# **MINUTES**

of a meeting of the Bayside Local Planning Panel held in the Committee Room, Botany Town Hall Corner of Edward Street and Botany Road, Botany on Thursday 15 August 2019 at 6.12 pm.

### 5.1 Draft Planning Proposal - 2 and 4 Guess Avenue, Wolli Creek

Figure 1: Bayside Local Planning Panel Recommendation.

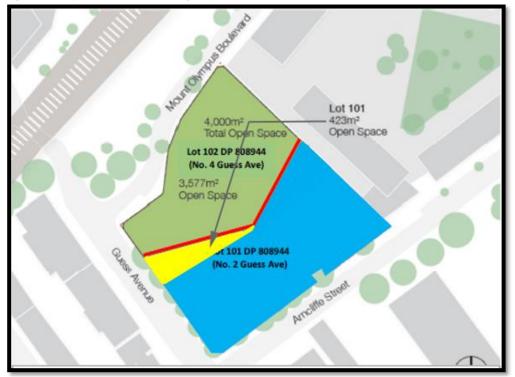
The Panel considers that the amenity of the future open space would be greatly improved with height and density controls for Lot 101 being less than proposed. It is also recommended that proposed 423m2 of open space to be retained on Lot 101 (shown in Figure 1 of the Officer's report) should be mirror-imaged to the south, so that a larger open space frontage to Guess Avenue is provided. See figure 1 below:

- 1 Amend the zoning map as recommended by the Panel in Figure 1 of this report;
- 2 Carry out further investigations (as highlighted in the SGS Report) in relation to:
  - a. ways to improve pedestrian access to nearby regional open space, in particular Cahill Park on the eastern side of the Princes Highway,
